# UNITED STATES PATENT AND TRADEMARK OFFICE

APPLICATION NO.	FILING DATE	FIRST NAMED INVENTOR	ATTORNEY DOCKET NO.	CONFIRMATION NO.
10/543,080	07/21/2005	Marco Pontanari	60130-2399; 02MRA0191	2571
26096 7590 02/21/2007 CARLSON, GASKEY & OLDS, P.C. 400 WEST MAPLE ROAD SUITE 350 BIRMINGHAM, MI 48009			EXAMINER KNIGHT, DEREK DOUGLAS	
			ART UNIT 3681	PAPER NUMBER
SHORTENED STATUTORY PERIOD OF RESPONSE		MAIL DATE	DELIVERY MODE	
3 MONTHS		02/21/2007	PAPER

**Office Action Summary**

**Figure 1: Taken from Figure 1 of KELLER (US 5,030,181)**

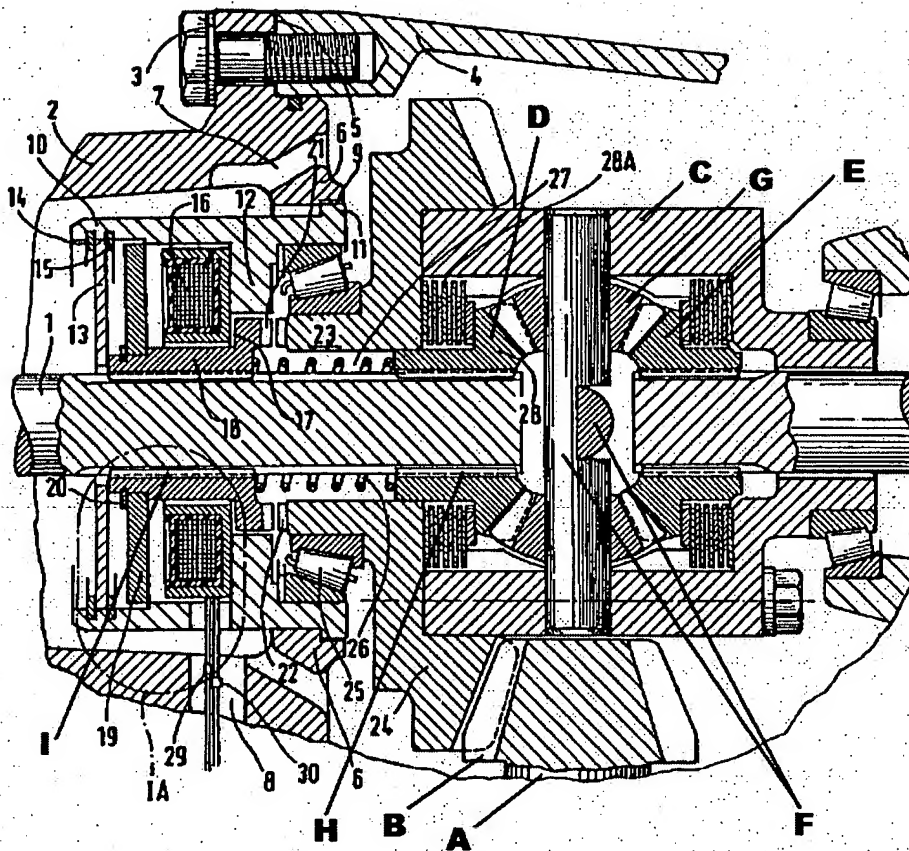
Please note that Figure 1 below has added reference letters to help identify features shown in **KELLER (US 5,030,181)**.

**Regarding claims 1 and 9:** **KELLER** discloses a drive axle assembly with a locking differential comprising a driving input (A), a carrier (C) including a pinion gear (B) driven by the driving input and a ring gear (24) in meshing engagement with said pinion gear a differential including a differential gear assembly supported within a differential case (24 and C); a pair of axle shafts (1) driven by the differential gear assembly for rotation about an axis; a locking mechanism including a shift collar (18) movable between an unlocked position where speed differentiation between said pair of

axle shafts is permitted and a locked position wherein said shift collar (18) directly engages the differential case (24) such that said differential case, said shift collar, and said pair of axle shafts are fixed for rotation together; and an electronic actuator (16) for generating an electronic signal to move the shift collar from said unlocked position to said locked position.

**Regarding claims 2 and 10: KELLER** shows the electronic actuator (16) including a coil (not numbered) mounted to an axle component (2) and surrounding the shift collar (18) wherein an electronic signal powers the coil to move the shift collar.

**Regarding claim 3 and 14: KELLER** shows the differential case (24 and C) includes a first case half (24) and a second case half (C) and the electronic actuator (16) selectively moves the shift collar to engage one of the case halves.

**Regarding claim 4: KELLER** shows a resilient member (26) for automatically returning said shift collar to the unlocked position when the coil is not powered.

**Regarding claim 6: KELLER** shows a washer (19) fixed to the outboard end of the shift collar. Although Keller does not show it, the washer is capable of reacting with a resilient member. Using the washer to react with a resilient member is simply intended use.

**Regarding claim 7,8, and 12: KELLER** shows the shift collar including an inboard end having a splined surface (21) and an out board end capable of supporting a resilient return member, the inboard end having a greater diameter than the outboard end. The coil defines a central bore surrounding the shift collar at the outboard end, said shift collar moving in an inboard direction in response to said coil being powered

via an electronic signal such that the splined surface (21) of the inboard end engages a mating splined surface (22) formed on said differential case (24) such that the differential case is locked to the pair of axle shafts.

**Regarding claim 11:** KELLER shows an axle housing (2) for substantially enclosing said carrier (C) and said pair of axle shafts (1) wherein said coil is supported by the axle housing.

**Regarding claim 15:** KELLER shows a pair of side gears (D and E) with one side being fixed to each of said pair of axle shafts and wherein said differential gear assembly includes a differential spider (F) having for support shafts oriented in an overall shape of a cross and four pinion gears (G), only 2 are shown in Figure 1 below, in meshing engagement with said side pair of gears with one of said four differential pinion gears being supported on each of said four support shafts and wherein said ring gear (24) is fixed to one of said first and second case halves such that said ring gear, said differential case, said differential spider, and said four differential pinion gears all rotate as one unit to transfer power to said pair of axle shafts via said pair of side gears when no speed differentiation is required and when speed differentiation is required said four differential pinion gears rotate on respective support shafts to speed up rotation of one of the pair of axle shafts via a respective one of said pair of side gears while slowing rotation of the other of said pair of axle shafts via a respective other said pair of side gears.

**Regarding claim 16:** KELLER shows one of said pair of axle shafts including a set of inboard splines (H) and a set of outboard splines (I), said set of inboard splines

cooperating with said respective one of said pair of side gears to fix said one of said pair of side gears for rotation with said one of said pair of axle shafts and said set of outboard splines cooperating with a splined bore formed inside said inboard of said shift collar.
